SUNDRY NOTICES AND REPORTS ON WELLS (DO NOT USE THIS FORM FOR PROPOSALS TO DRILL OR TO DEEPEN OR PLUG BACK TO A DIFFERENT RESERVOIR. USE "APPLICATION FOR PERMIT" (FORM C-101) FOR SUCH PROPOSALS.)		7. Lease Name or Unit Agreement Name
1. Type of Well: Oil Well <input type="checkbox"/> Gas Well <input type="checkbox"/> Other		8. Well Number
2. Name of Operator		9. OGRID Number
3. Address of Operator		10. Pool name or Wildcat
4. Well Location Unit Letter _____ : _____ feet from the _____ line and _____ feet from the _____ line Section _____ Township _____ Range _____ NMPM _____ County _____		
11. Elevation (Show whether DR, RKB, RT, GR, etc.)

MONUMENT G/SA UT BLK 15 N #15 - CURRENT WELBORE SCHEMATIC

**P&A WBD - Current Schematic****Well Name: NORTH MONUMENT G/SA UNIT #1515**

Operator: APACHE CORPORATION 303 Veterans Airpark Ln Midland, TX 79705	OGRID: 873
	Action Number: 547957
	Action Type: [C-103] NOI Plug & Abandon (C-103F)

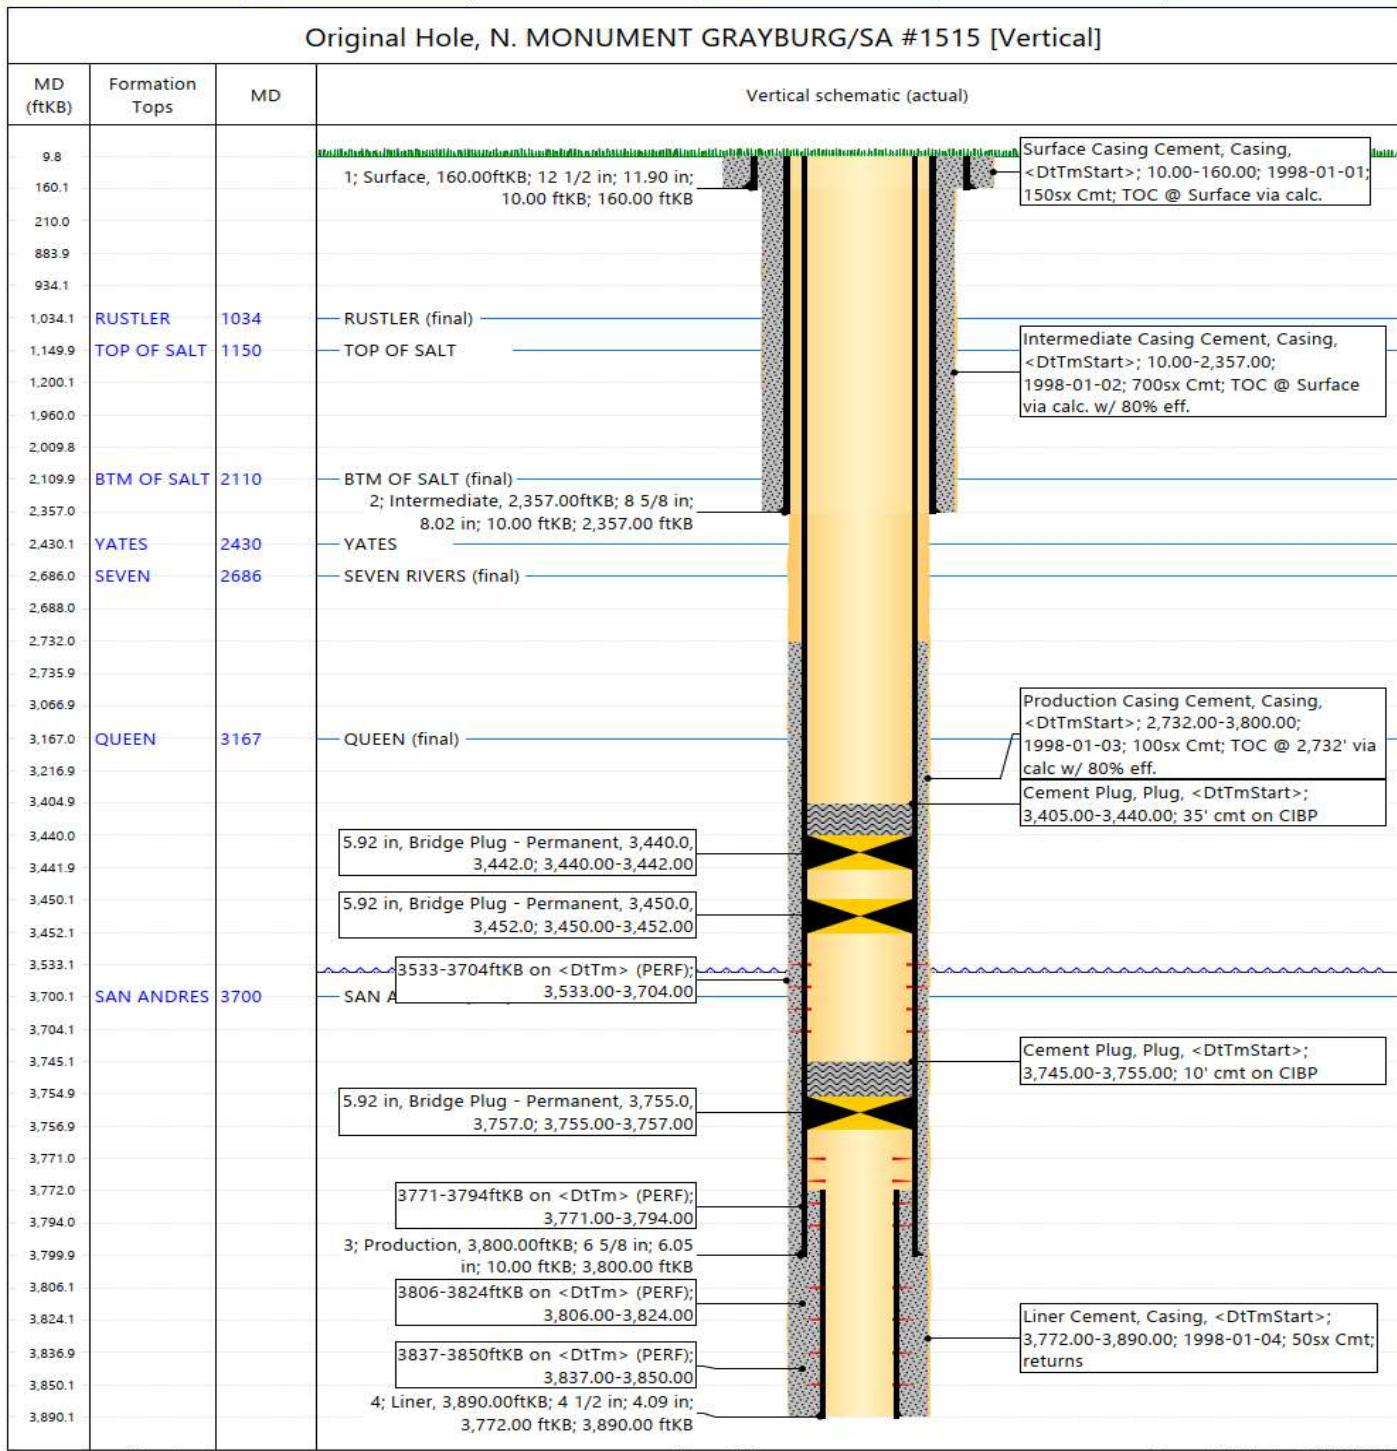
3. MIRU service rig and associated equipment; NU and test BOP.
4. Well has a 6-5/8" CIBP set at 3,440' w/ 35' of cement on top. **Add 25' of cement to plug - recorded only 10' spotted on plug**
